Appendix 11.3

Flood Risk Assessment

Annex C: Assessment Supporting Information

CSA ID Number: 1 + 2

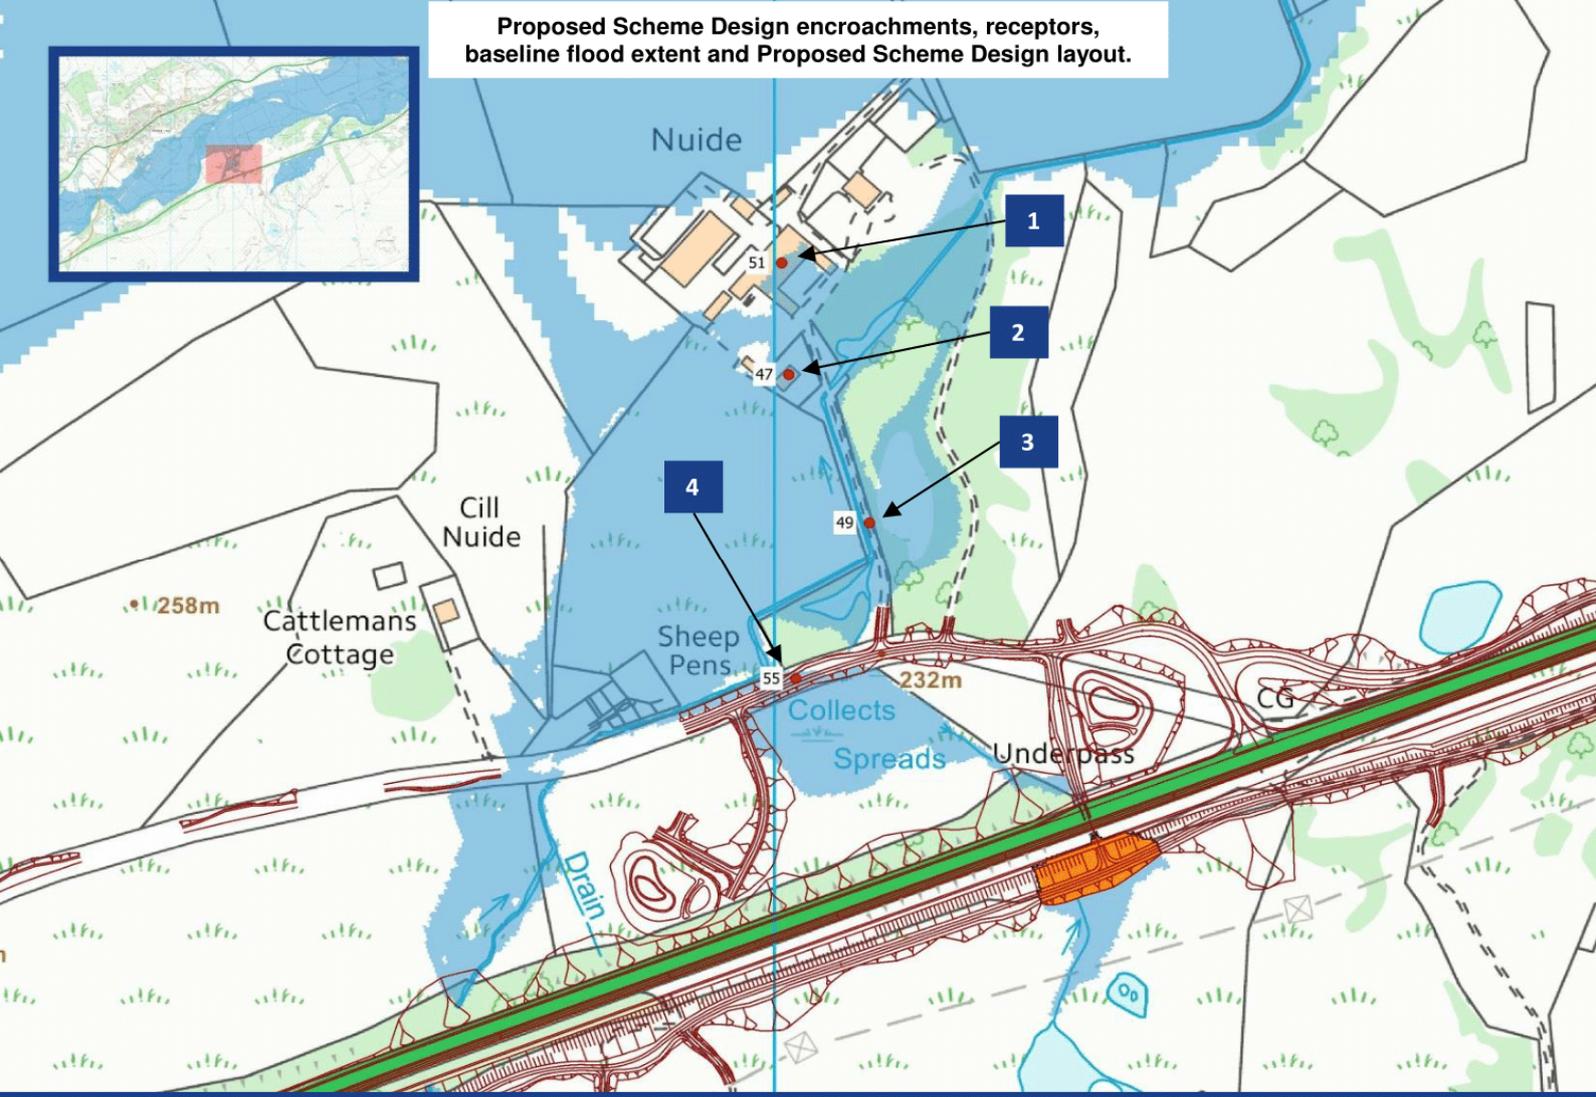
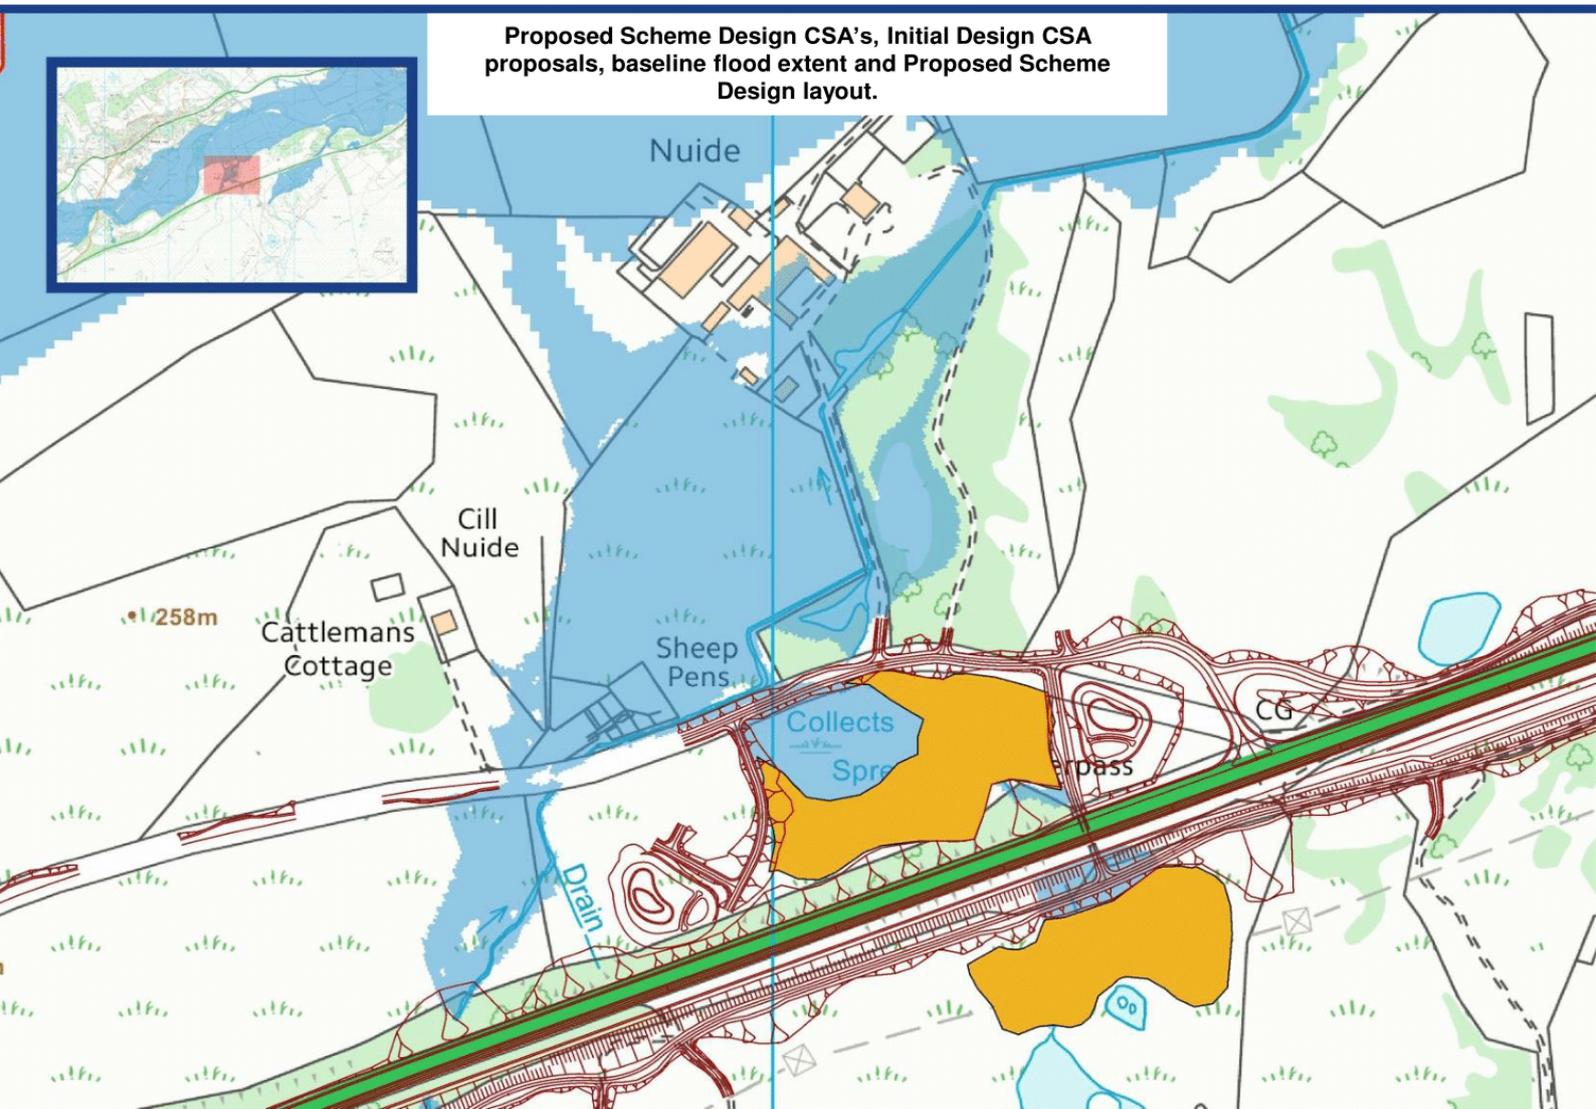
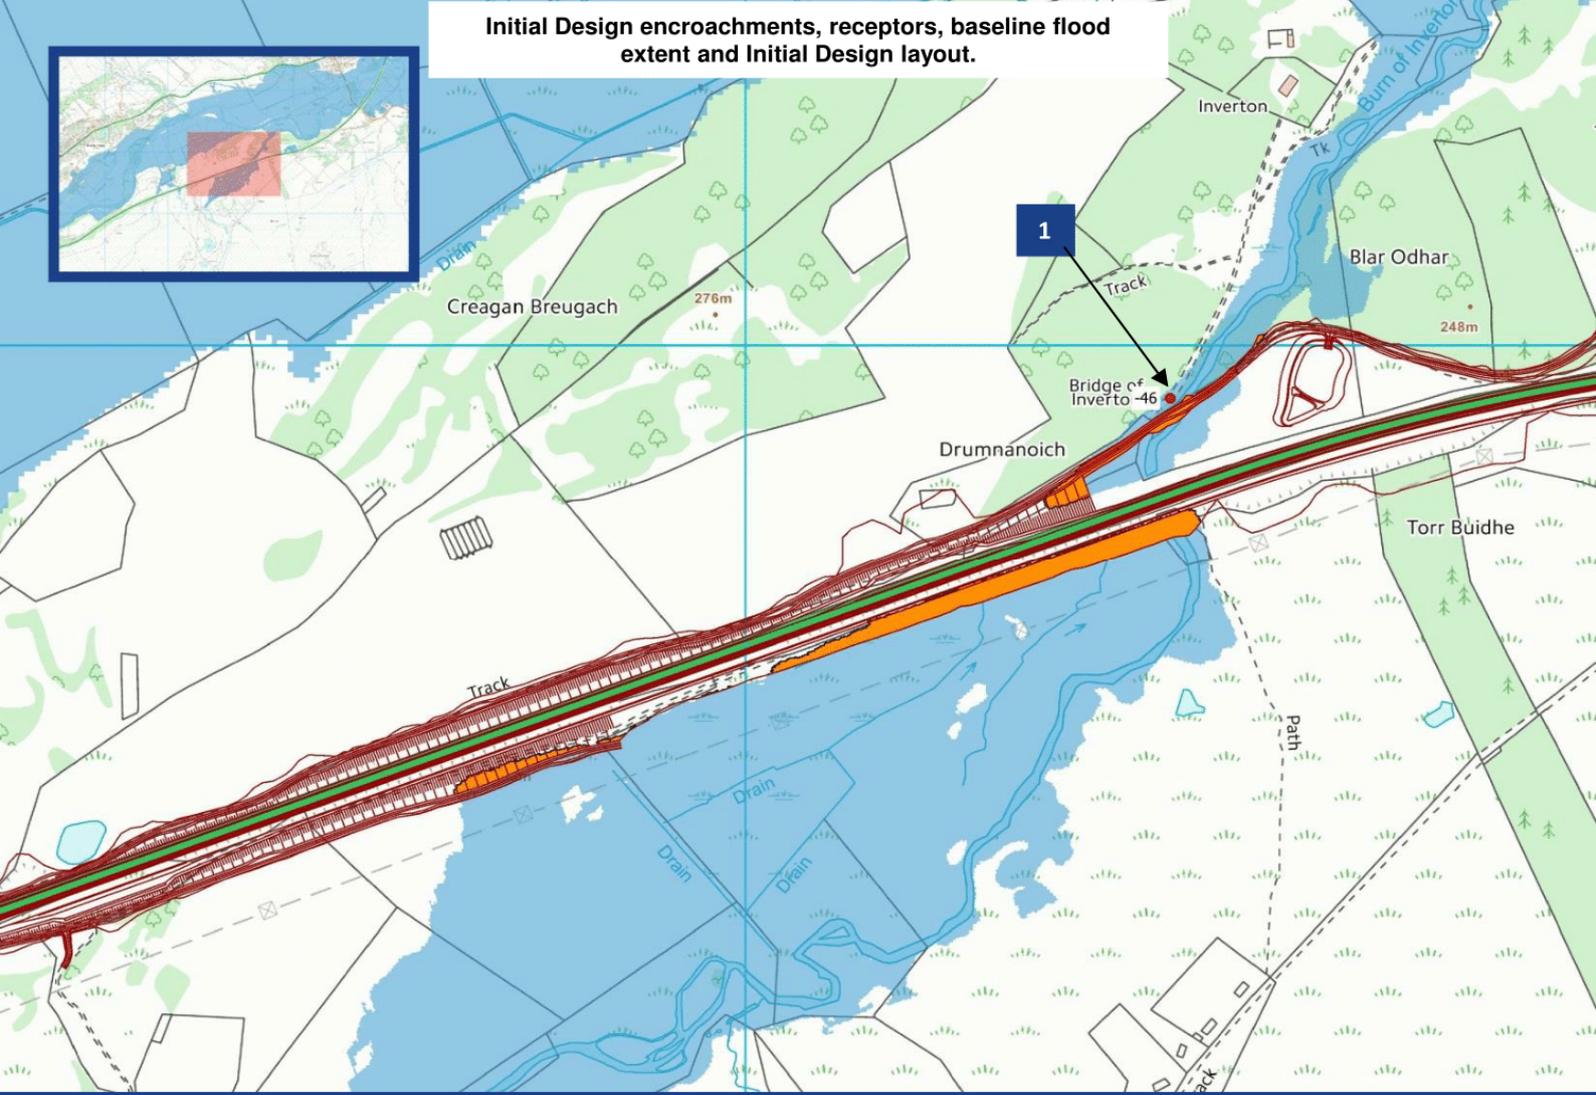
Ecology: CFS 1 - Impacts on areas of dry heath (Annex I habitat which, whilst relatively common in Scotland, is rare across Europe). Reduce extent from areas of dry heath, or remove completely.

If dry heath can be reinstated then impact will be lessened. Should ground levels be reduced, it is unlikely that there will be suitable conditions to restore the full extent of dry heath. Details of required excavation depths will determine final assessment outcome.

C&PA: CFS 2 - In close proximity to access track to Nuide Farm; potential for track to flood. Move area away from track.

Geology: CFS 1 - Partially located on shallow peat (0.5 - 1.0m) and encroaches swamp/ mire. Reshape to avoid above areas or relocate 20m north.

Access track has been pulled tighter against the mainline reducing the encroachment volume. Culvert size has been informed by hydraulic modelling and CSA design to maximise upstream storage potential.

The final option selected is for there to be an upstream CSA which will provide as much storage as is feasible at detailed design with a second downstream CSA which will provide the remaining required compensation. This will mitigate the impacts resulting from the loss of floodplain storage.

CSA ID Number: 3

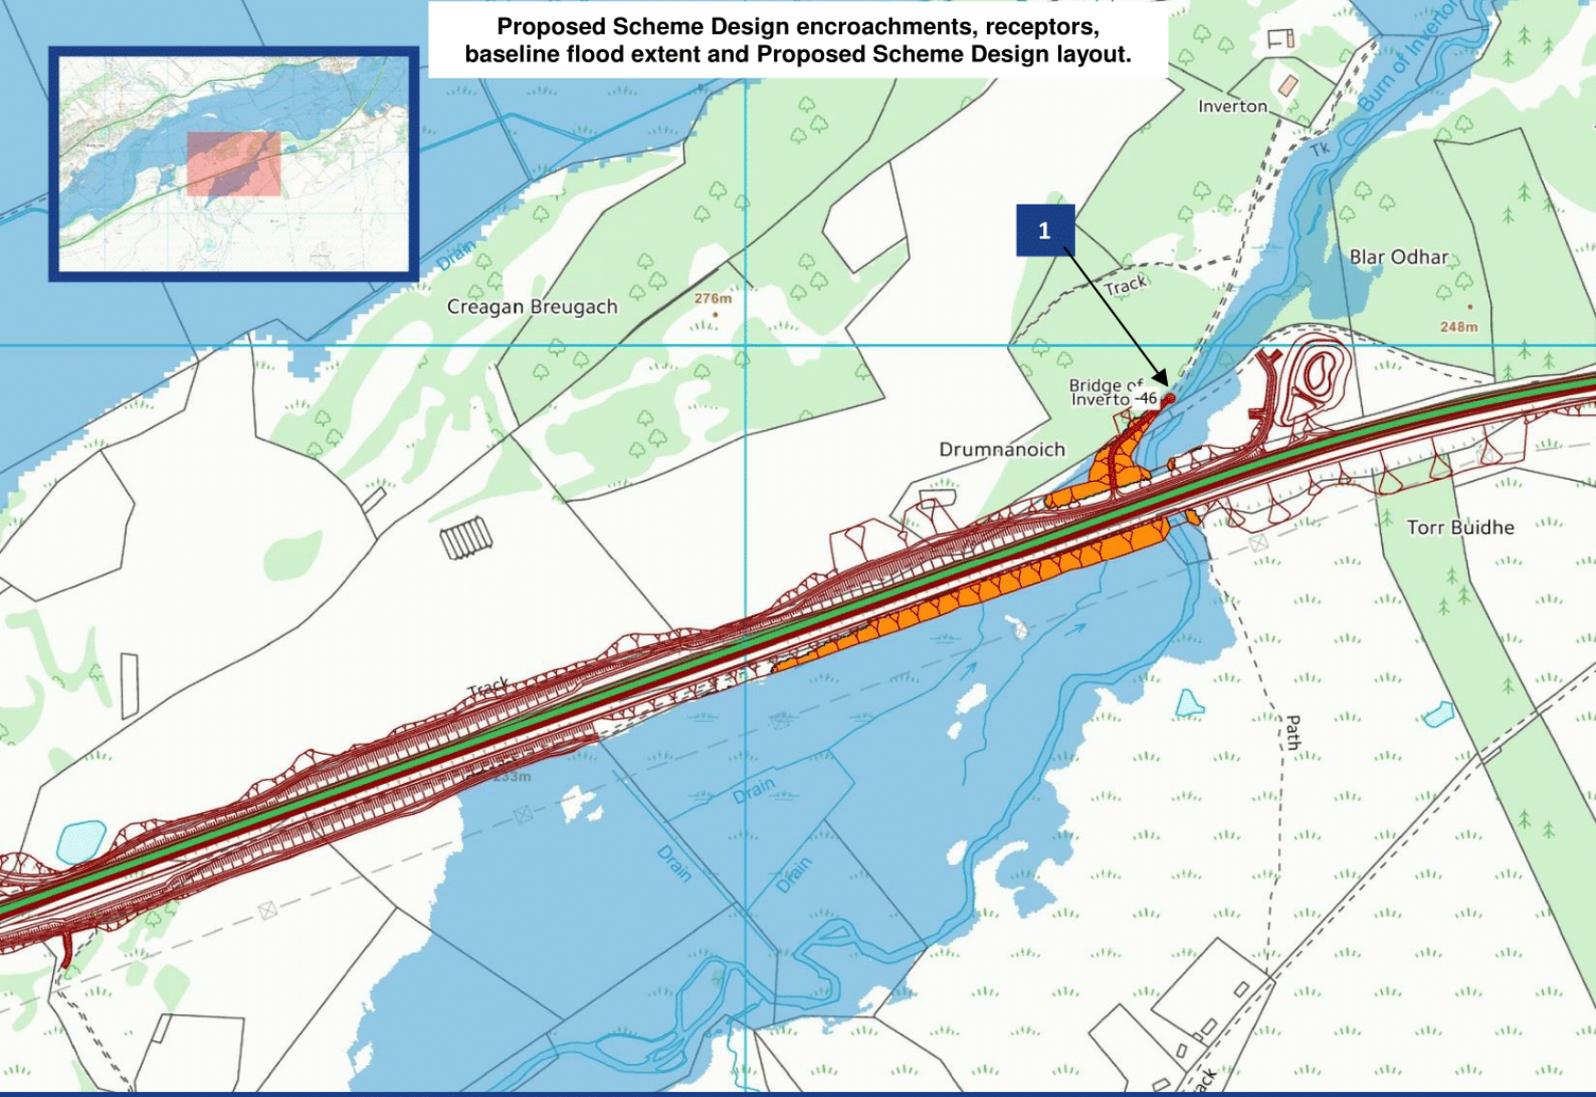
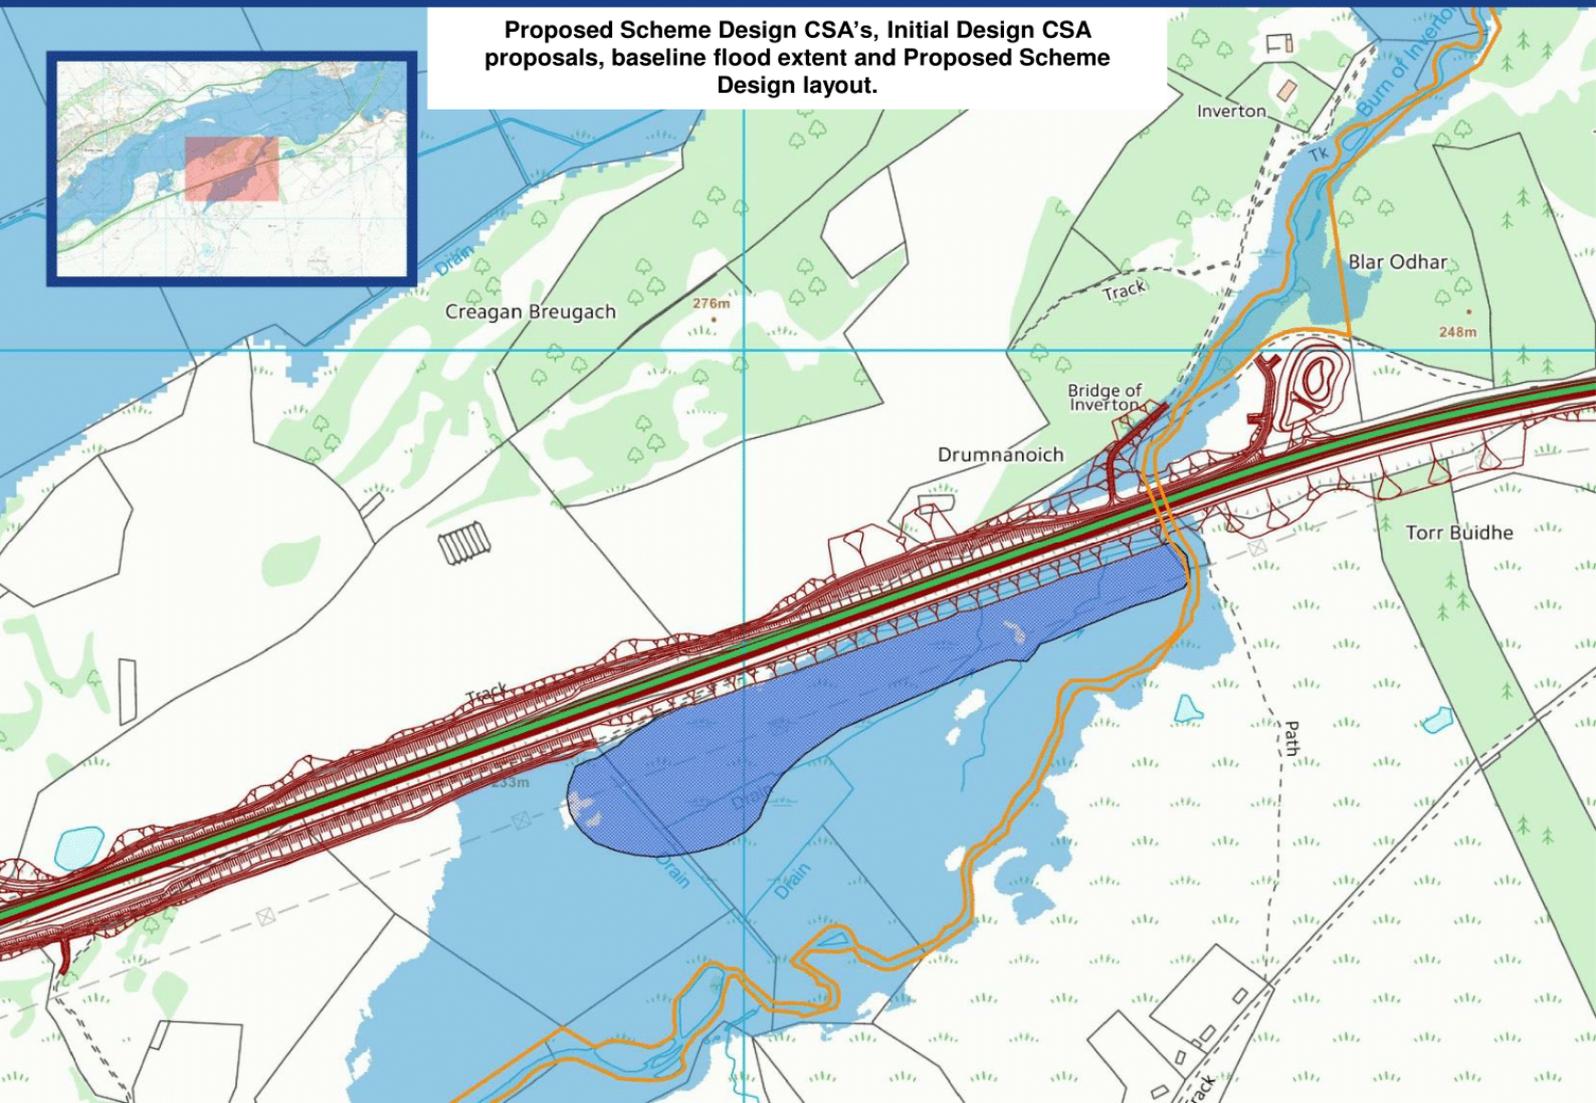
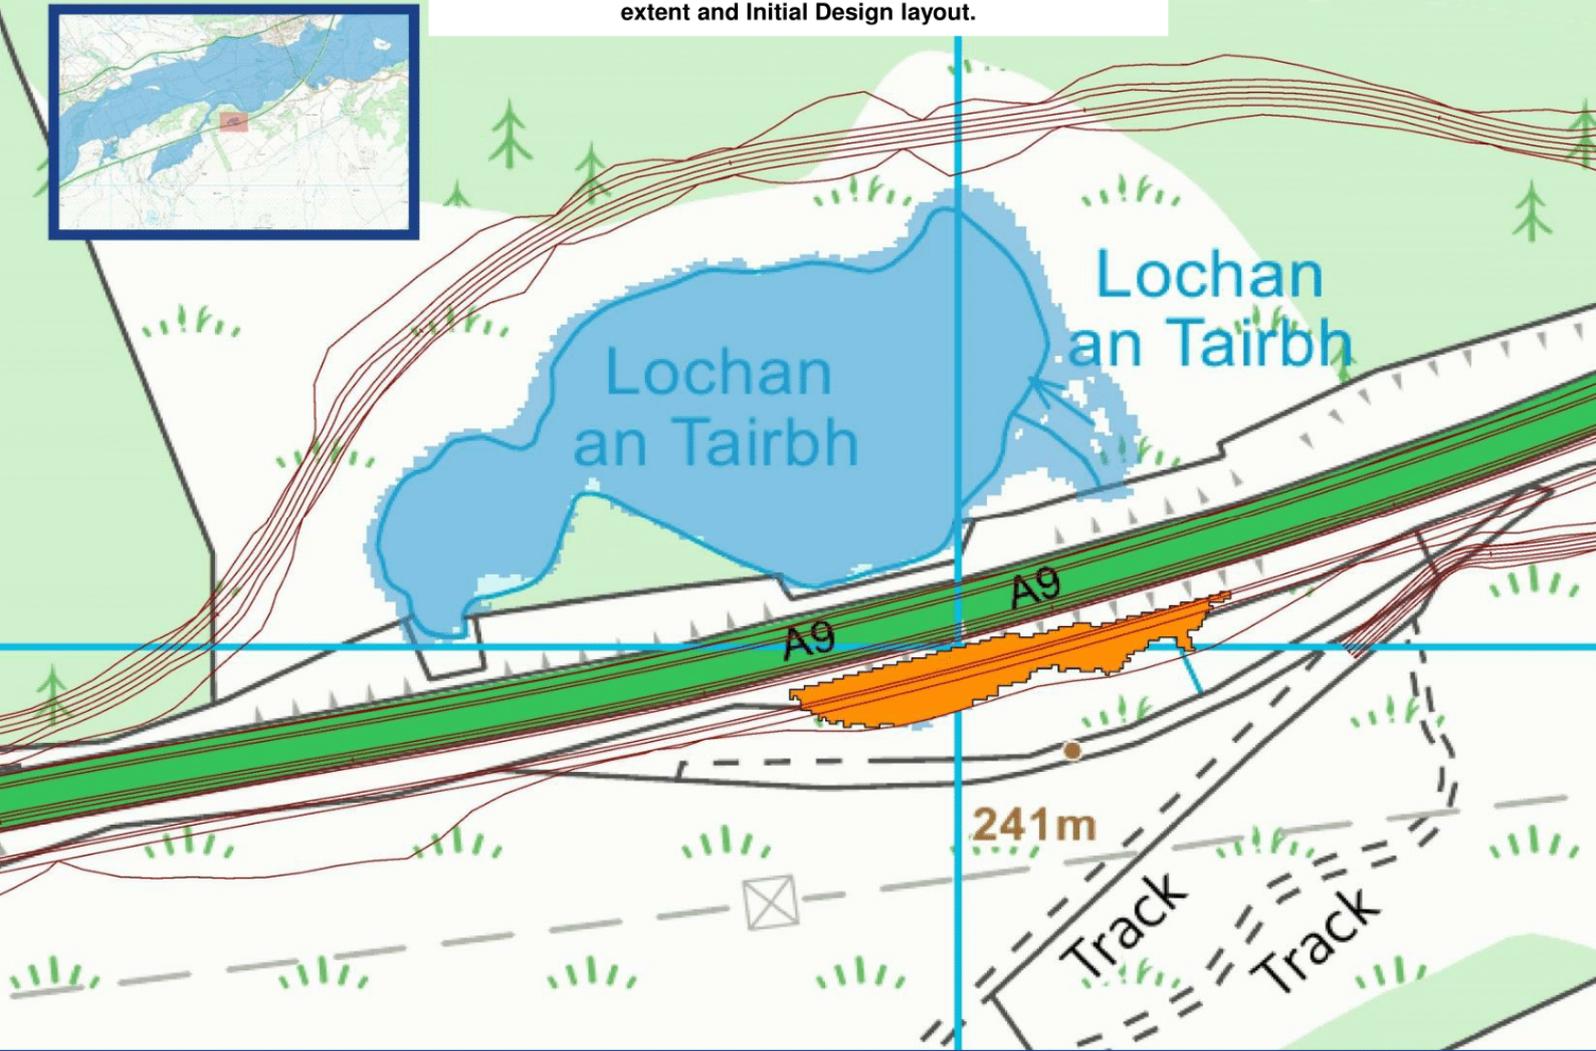
Ecology: Impacts on River Spey SAC. Reshape to avoid River Spey SAC at eastern extent. If this cannot be reshaped, it will result in Likely Significant Effect (LSE) in the Habitats Regulations Appraisal (HRA) and an appropriate assessment, a more stringent assessment compared to EIA, will have to be carried out. If the area can be reshaped, a positive may be that breeding birds would benefit from locally deep excavations, providing ephemeral wetland features (e.g. scrapes, ditch, etc.).

Geology: Partially located on peat (up to 1.5m) and M23 mire. Reshape to avoid above areas or relocate 550m west or 650m east. If peat can be reinstated then impact could be lessened; to reinstate, over-excavation would be recommended. Details of required excavation depths will determine final assessment outcome.

Access track at the western end has been pulled tighter against the mainline and embankments steepened reducing the encroachment volume in this area. Access track downstream of the crossing has been realigned against the mainline however a connection to the existing access track has been introduced in the floodplain resulting the overall decrease in encroachment volume being less than could be achieved with further design consideration. Crossing size has been informed by extensive hydraulic modelling to not pass more flow downstream at any return period or storm duration.

The final option selected is for compensatory storage to be provided by upstream displacement. Extensive hydraulic modelling has been carried out to inform the mainline crossing size such that it does not pass more flow downstream at any return period or storm duration. The crossing size determined is a twin 4.2m x 3.6m box culvert arrangement.
